REVERSE CAMERA SLOW RESPOND FOR NAVARA 10.2" PLAYER

Memorandum

Date: 17 Mar 2018

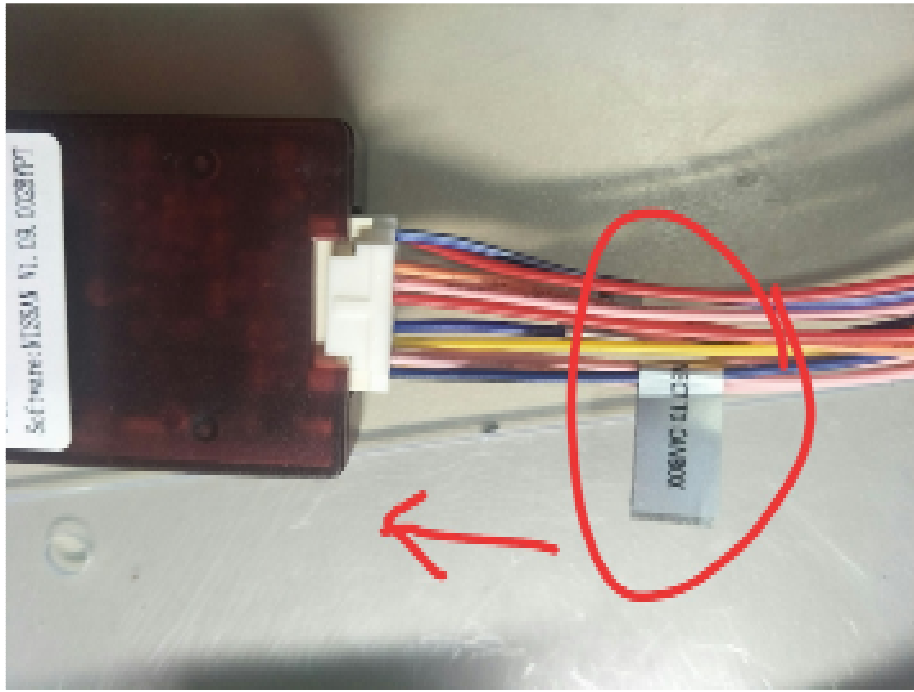
There is several reports few customer has problem with reverse camera slow respond for Navara 10.2" Screen (Batch ID Jan 2018 to now). Details as below: -

- 1) **Symptoms:** - Reverse image will take 23 second extra once done with 'REVERSE' gear usage.
- 2) **Impact:** - Delay 23 second to play music after reverse gear.
- 3) **Risk:** - LOW RISK – No impact to System
- 4) **Finding:** - Problem due to installation error (wrong canbus cabling and canbus switch location).
- 5) **Right method:** -
 - a. Canbus cabling:- Cable connector need to follow cable marker

b. Canbus switch – Need to be in RIGHT
